# Memo

**To:** The Atherton Planning Commission  
**From:** Sally D Bentz-Dalton, Town Arborist  
**CC:** Sean Manalo, Associate Planner  
**Date:** 9/30/24  
**Re:** Tree Protection Zone (TPZ) Exception 64 Winchester

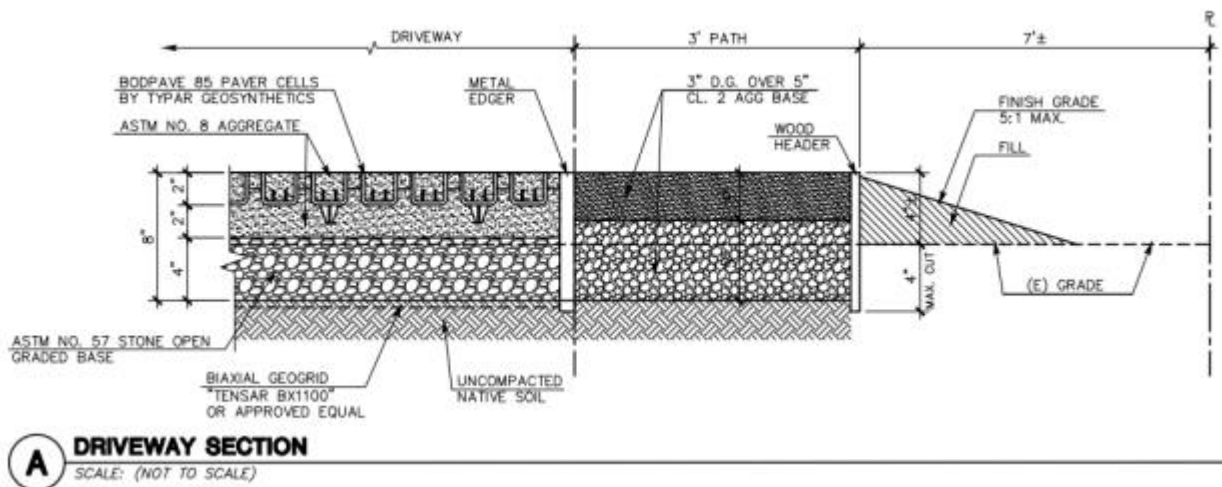
The applicant is proposing a new driveway and garage which require 2 TPZ requests.

Request 1: Tree #5 Coast Live Oak – 36” dbh, 3.33x for a new driveway – 10’ away

Request 2: Tree #43 – Redwood – 25” dbh, 7x for a garage – 14.5’ away

## Proposed

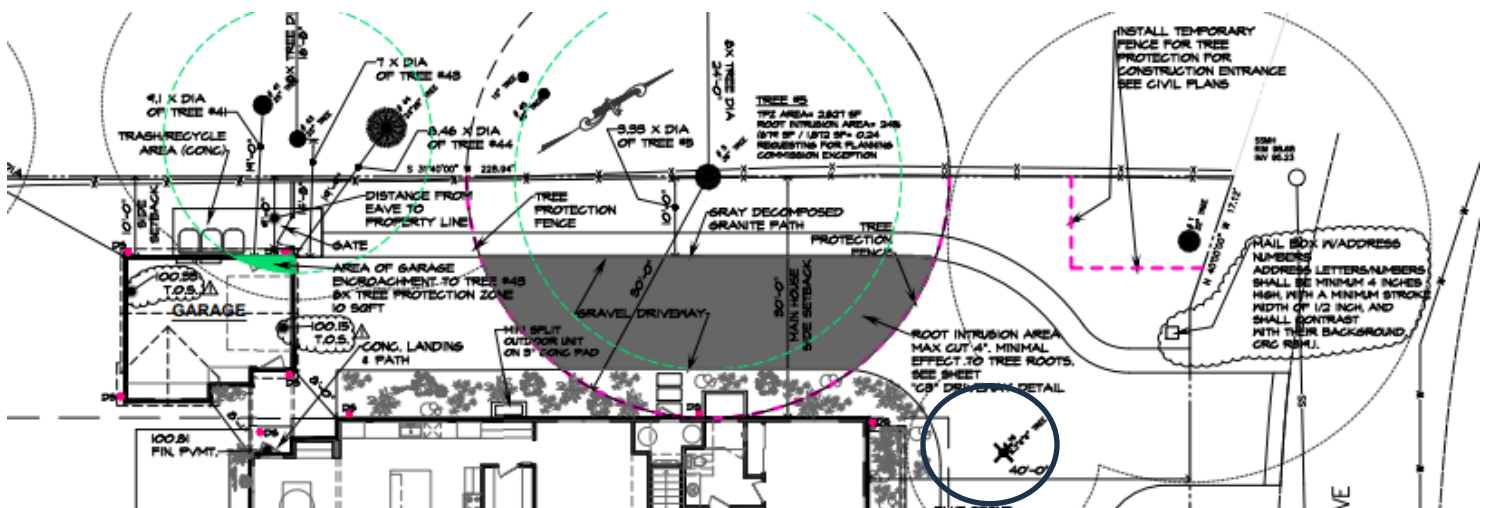
This coast live oak is in fair condition and is the neighbor's tree. The applicant is proposing to build a new driveway 10' away from this tree. Per the regulations a new driveway location is required to be 8x away. However, this applicant is proposing to build it 3.33x away. The arborist stated that with the 3.33x tree protection zone that 24% of the roots will be impacted. However, if the Biaxial geogrid is required than the

For tree #5 at 3.33x is the critical root zone. Roots are found in the first 3' of the soil. I can only allow 3.33x for this tree because of only 4" of soil will be excavated by hand. The project arborist must be on site for all work 10x away. If this driveway was proposed and not raised Biaxial, I would not be able to approve it at 3.3x times due to the amount of grading that close to the structural roots.

I can recommend the below two requests based on neighbor's approval, that any roots 2" and greater can be protected, that the driveway uses Biaxial Geogrid with only 4" of rough grading, and Mr. Kielty's recommendations are followed, and less than 26.5% of roots will be affected.

- Required to be installed and **shown on G&D plans** - Biaxial Geogrid (Tensar BX-1100) as an underlayment to be placed on top of the parent soil. Minor rough surface grading not to exceed more than **4"**. Biaxial Geogrid (Tensar BX-1100 or equivalent) to be placed on the soil with only hand-tamped compaction preparation used. Edging needed is recommended to be supported above ground by individual stakes.
